SUBJECT: ISSUANCE OF AMENDMENTS NOS. 180, 180, AND 177 TO FACILITY OPERATING  
LICENSES DPR-38, DPR-47, and DPR-55 - OCONEE NUCLEAR STATION,  
UNITS 1, 2, AND 3 (TACS 75074/75075/74887)

These amendments revise the TSs to account for minor changes in power peaking and control rod worths resulting from the Oconee Unit 3 core reload. In addition, the use of the VIPRE thermal hydraulic code is referenced and all specifications associated with two reactor coolant pump operations are deleted.

SAFETY EVALUATION BY THE OFFICE OF NUCLEAR REACTOR REGULATION  
RELATED TO AMENDMENT NO.180 TO FACILITY OPERATING LICENSE DPR-38

OCONEE NUCLEAR STATION, UNITS 1, 2 AND 3

Figure 2.1-2  
OCONEE NUCLEAR STATION

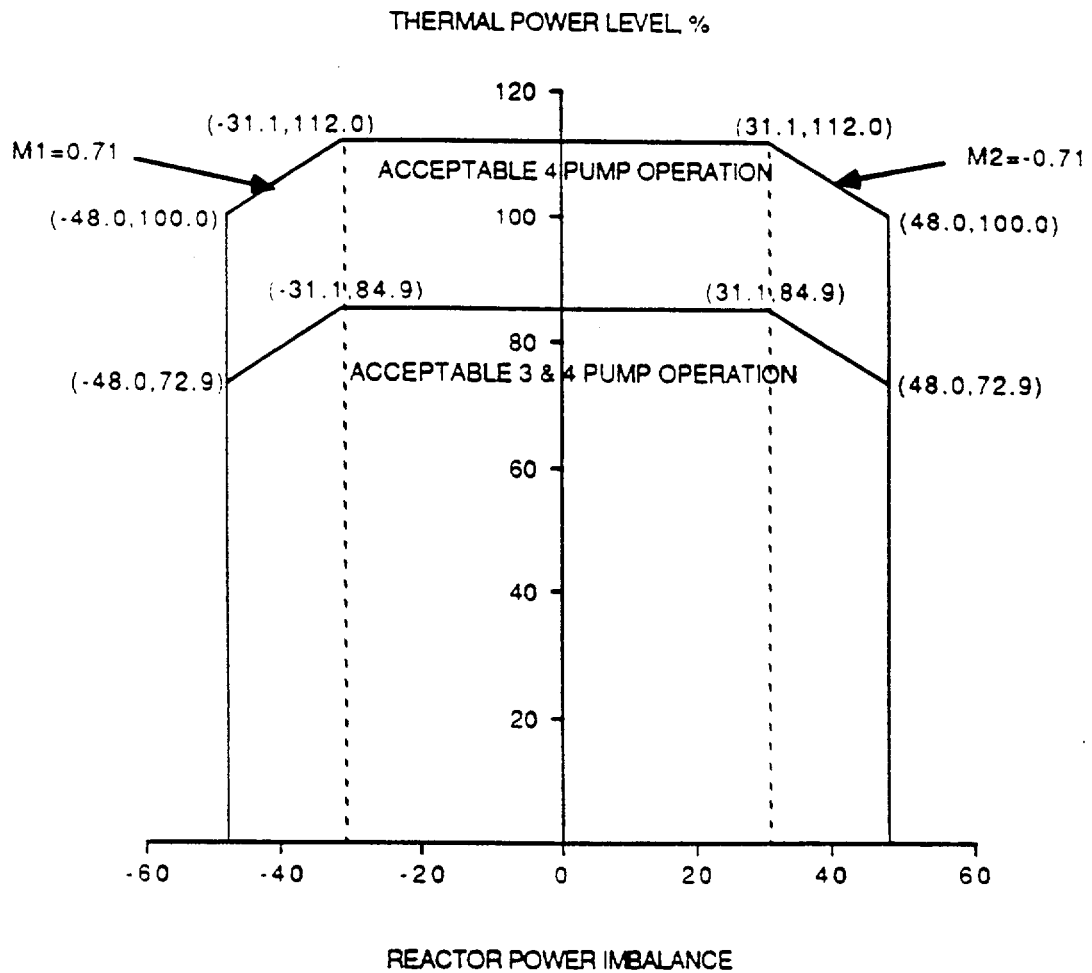
Figure 2.1-2(5), define the values of reactor power as a function of axial imbalance that correspond to the more restrictive of two thermal limits - MDNBR equal to the DNBR limit or the linear heat rate equal to the centerline fuel melt limit.

The core protection safety limits are based on an RCS flow less than or equal to 385,440 gpm (4 pump operation). Three pump operation is analyzed assuming 74.7 percent of four pump flow. The maximum thermal power for three pump operation is 84.9 percent (Figure 2.1-2) due to a power level trip produced by the flux/flow ratio (74.7 percent flow x 1.07 = 79.9 percent power = 84.9 percent power adding the maximum calibration and instrument error).

The licensee performed the reload analysis using the approved reload design methodology described in DPC-NE-1002A, "Oconee Nuclear Station Reload Design Methodology II." The flux/flow/imbalance safety limit change is necessary because of the minor changes in the power peaking and control rod worth. The changes in safety limits also affect the limiting safety system settings. The flux/flow/imbalance safety limit change is a result of maneuvering analysis on fuel depletion, integral rod worth, and power maneuver. For the four-pump operation, the maximum power imbalance is reduced from the current value of 49.5 percent to 48 percent. For three-pump operation, the maximum allowable power level is reduced from 88.07 percent to 84.9 percent. The calculation of the allowable power level for the three-pump operation is based on an assumed reactor coolant system flow rate of 74.7 percent of the rated flow, a flux/flow trip setpoint of 1.07, and a power measurement uncertainty of 5 percent. This method is the same as that for the previous cycles except that the power uncertainty of 5 percent is obtained using the square root of sum of the squares method to account for the uncertainties associated with heat balance error, TS allowance for calibration of the excore detectors to the heat balance, transient nuclear instrument error, and an allowance for the uncertainty of the flux/flow imbalance trip function hardware. Since the error adjustment of the flux/flow/imbalance safety limits would result in a setpoint of 79.9 percent, the same as the current Reactor Protection System (RPS) maximum allowable setpoint, the RPS allowable setpoint in Figure 2.3-2 was unchanged.

Figure 2.3-2

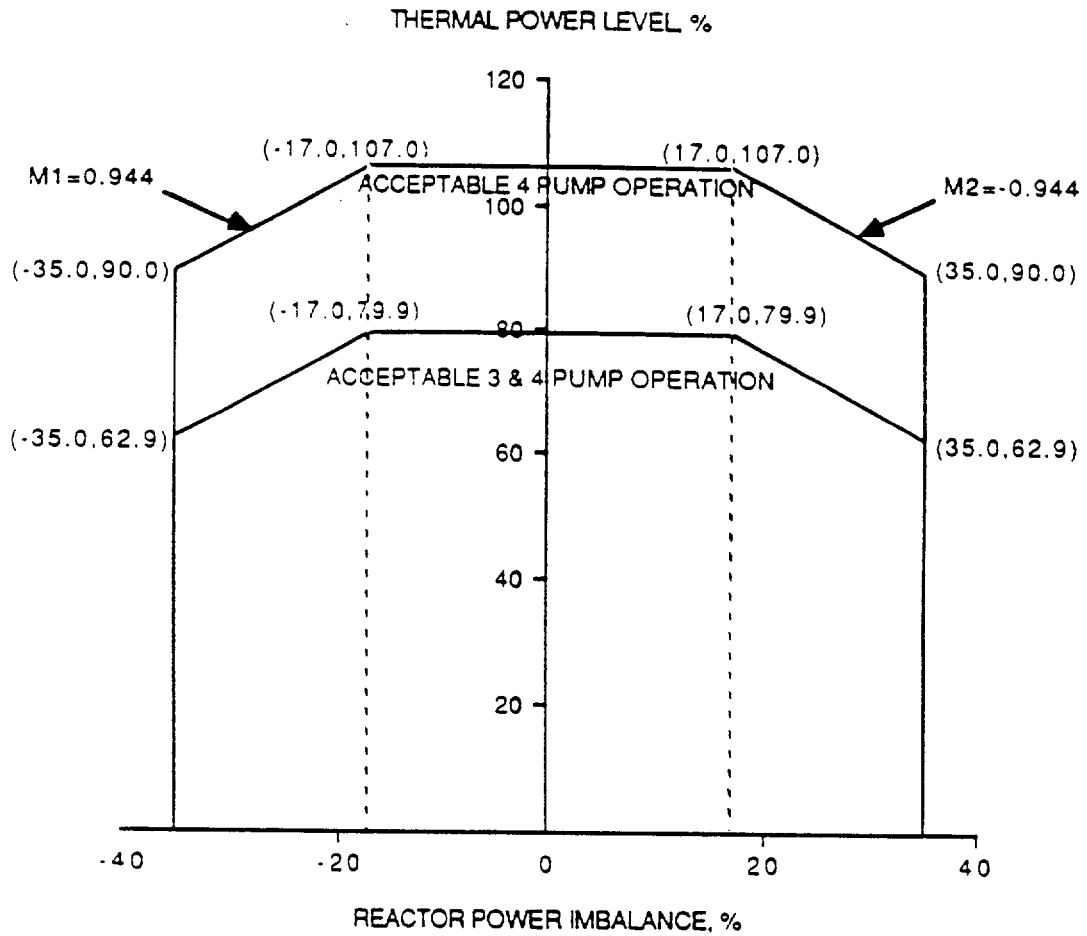
The reactor power imbalance (power in the top half of the core minus the power in the bottom half) reduces the power level trip produced by the flux/flow ratio as shown in Figure 2.3-2. The flux/flow ratio reduces the power level trip and associated power-imbalance boundaries by 1.07% for a 1% flow reduction. The power-imbalance boundaries shown in Figure 2.3-2 are established to prevent fuel thermal limits, DNBR and centerline fuel melt limits, from being exceeded.
